Shop Drawing Submittal Review

Project Name: Webster University-**ISB**

Copies	No.	Description
1 PDF	221423P01	(Submittal No.'s)
		(Cannon #221423-002) - (Paric #15051-) - (WES #607)
		➤ Storm Drainage Piping Specialties
		• Wade Roof Drain – RD-1 & OD-1
		• J.R. Smith Roof Drain – RD-2
		• Wade Down Spout Cover – DN-1

PROJECT NAME: Webster University
 LOCATION: ISB
 CLIENT PROJ. NO.: St. Louis Missouri
 WES PROJ. NO.: N/A
 607
 SPEC SECTION: 22 1423 Storm
 Drainage Piping
 Specialties
 SUBMITTAL ITEM: See Below -

**RD-1**

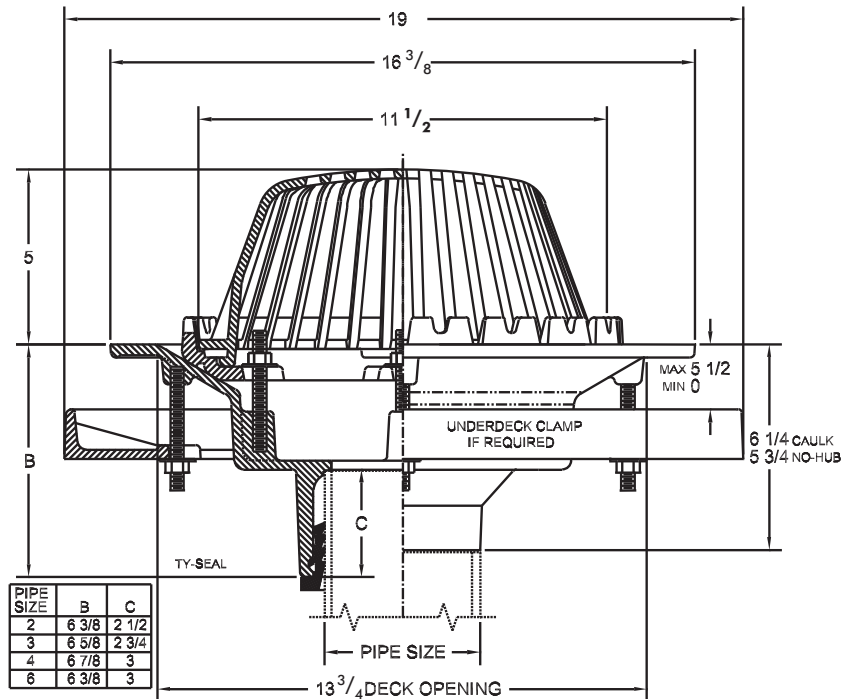
NO EXCEPTION TAKEN					
		MAKE CORRECTIONS NOTED, NO RESUBMITTAL:				
			AMEND AND RESUBMIT			
				REJECTED, SEE REMARKS:		
					REVIEWED ONLY	
NEC	MCN	AAR	REJ	REV	ITEM	REMARKS
X					Roof Drain – RD-1 Wade Model 300042xNH5253	
X					Roof Drain – RD-2 J.R. Smith Model 1900Y-R-C	
X					Roof Drain – OD-1 Wade Model 300042xNH5253SD	
	X				Down Spout Cover – DN-1 Wade Model 394185x	Specified to be vandal proof. Refer to drawing P0601.
